PN Number 125 Revision 1

ALUDRA V1I2 N270 heatsink change notification

Issue Date:	16th April 2012	Circulation:	General
Board Version:	1	Board Issue:	2
ECO Reference:	3783	MODBOX:	A

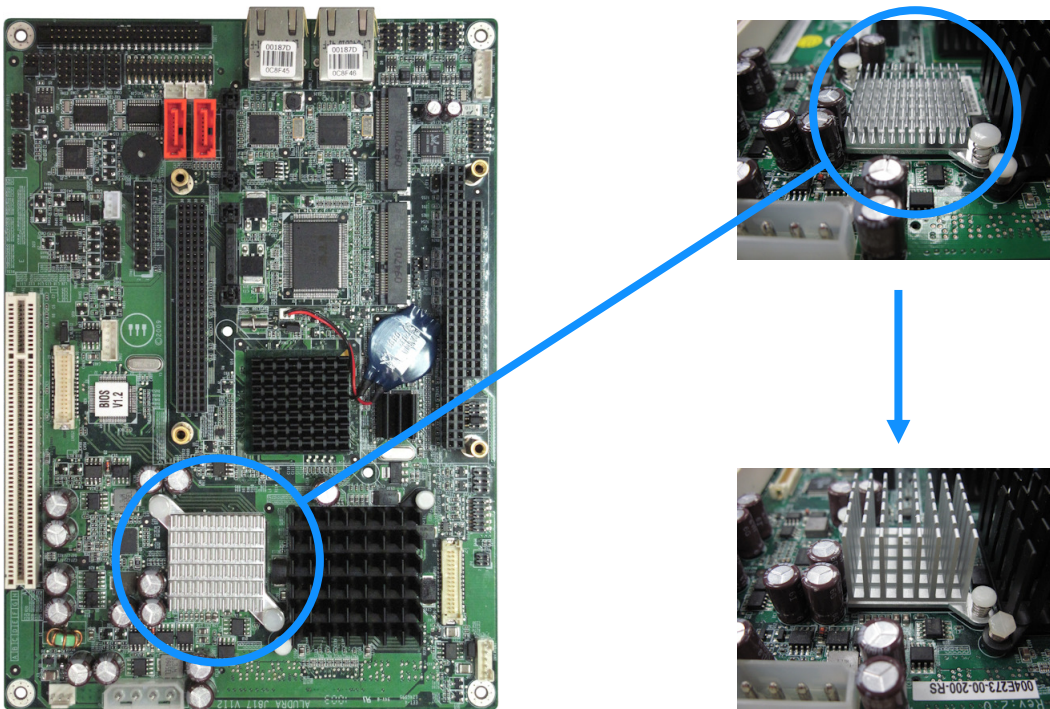
This product notice is to highlight that the ALUDRA V1I2 shall now be shipped with a 20mm high CPU heatsink to improve thermal performance of the board in high ambient temperatures.

The CPU heatsink has been changed from an 8mm high to a 20mm high part.

It is advised that your system is reviewed to ensure future deliveries of the ALUDRA do not pose mechanical incompatibility issues.
